Access Compliance Report

Public Rights-of-Way

Intersection ID: 29473	Main Street: HAWTHORNE BRIDGE CT	Cross Street: HAWTHORNE LN	Location: NW
ADA ID: C13412A435BF	Ramp Type: BlendTrans1	Initial Pass/Fail: Fail	Overall Compliance: No
		Severity Score: 25

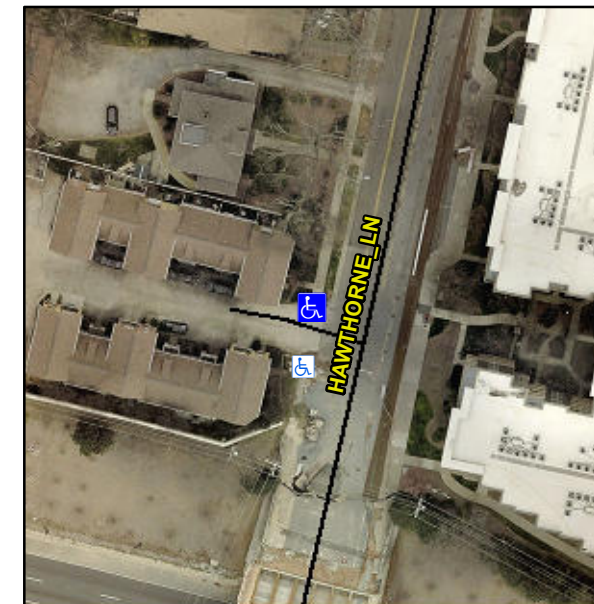
Not Found, R304.5.3

Compliance	Description	Data	Compliance	Description	Data
N/A	Ramp Length (in)	49.5	Yes	BlendTrans Slope (%)	1.7
Yes	Ramp Width (in)	48.0	No	BlendTrans XSlope (%)	9.2
N/A	Flare Type LT	N/A	N/A	Flare Type RT	N/A
N/A	Flare Slope LT (%)	N/A	N/A	Flare Slope RT (%)	N/A
N/A	Flare Traversable LT?	N/A	N/A	Flare Traversable RT?	N/A
N/A	Landing Length (in)	N/A	N/A	DWS Provided?	N/A
N/A	Landing Width (in)	N/A	N/A	DWS Contrast?	N/A
N/A	Landing Slope (%)	N/A	N/A	DWS Length (in)	N/A
N/A	Landing X Slope (%)	N/A	N/A	DWS Full Width?	N/A
N/A	Landing Curb? (Y/N)	N/A	N/A	DWS Offset (in)	N/A
N/A	Shared Landing?	N/A			
N/A	Gutter Ponding?	N/A	N/A	Gutter Slope (%)	N/A
N/A	Gutter Lip Ht (in)	N/A	N/A	Gutter X Slope (%)	N/A
N/A	Painted X Walk1?	No	N/A	Painted X Walk2?	N/A
	X Walk 1 Direction	To S		X Walk 2 Direction	N/A
	X Walk 1 Width (in)	N/A		X Walk 2 Width (in)	N/A
	X Walk 1 Slope (%)	0.3		X Walk 2 Slope (%)	N/A
	X Walk 1 X Slope (%)	8.5		X Walk 2 X Slope (%)	N/A

Remove & Replace Curb Ramp With Two New Directional Ramps or Equivalent.
